Access Compliance Report

Public Rights-of-Way

(Curb Ramps)

Intersection ID: 30117	Main Street: CLOONEY_LN	Cross Street: DAVIS_FOREST_LN	Location: NW
ADA ID: 71407E5A4984	Ramp Type: PerpDiag	Initial Pass/Fail: Fail	Overall Compliance: No
Severity Score: 12.5			
Codes/Mitigation Info/Possible Solution		Field Measurements/Component Compliance

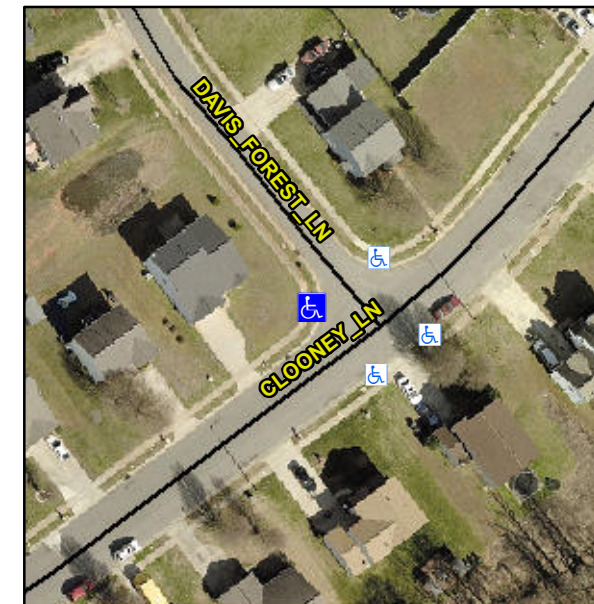
Compliance	Description	Data	Compliance	Description	Data
N/A	Ramp Length (in)	54.0	No	Ramp Slope (%)	10.6
Yes	Ramp Width (in)	54.0	Yes	Ramp XSlope (%)	1.5
N/A	Flare Type LT	N/A	N/A	Flare Type RT	N/A
N/A	Flare Slope LT (%)	N/A	N/A	Flare Slope RT (%)	N/A
N/A	Flare Traversable LT?	N/A	N/A	Flare Traversable RT?	N/A
N/A	Landing Length (in)	N/A	N/A	DWS Provided?	N/A
N/A	Landing Width (in)	N/A	N/A	DWS Contrast?	N/A
N/A	Landing Slope (%)	N/A	N/A	DWS Length (in)	N/A
N/A	Landing X Slope (%)	N/A	N/A	DWS Full Width?	N/A
N/A	Landing Curb? (Y/N)	N/A	N/A	DWS Offset (in)	N/A
N/A	Shared Landing?	N/A			
N/A	Gutter Ponding?	N/A	N/A	Gutter Slope (%)	N/A
N/A	Gutter Lip Ht (in)	N/A	N/A	Gutter X Slope (%)	N/A
N/A	Painted X Walk1?	No	N/A	Painted X Walk2?	No
	X Walk 1 Direction	To SE		X Walk 2 Direction	To NE
N/A	X Walk 1 Width (in)	N/A	N/A	X Walk 2 Width (in)	N/A
	X Walk 1 Slope (%)	1.0		X Walk 2 Slope (%)	2.0
	X Walk 1 X Slope (%)	2.6		X Walk 2 X Slope (%)	0.6

Remove & Replace Curb Ramp With Two New Directional Ramps or Equivalent.
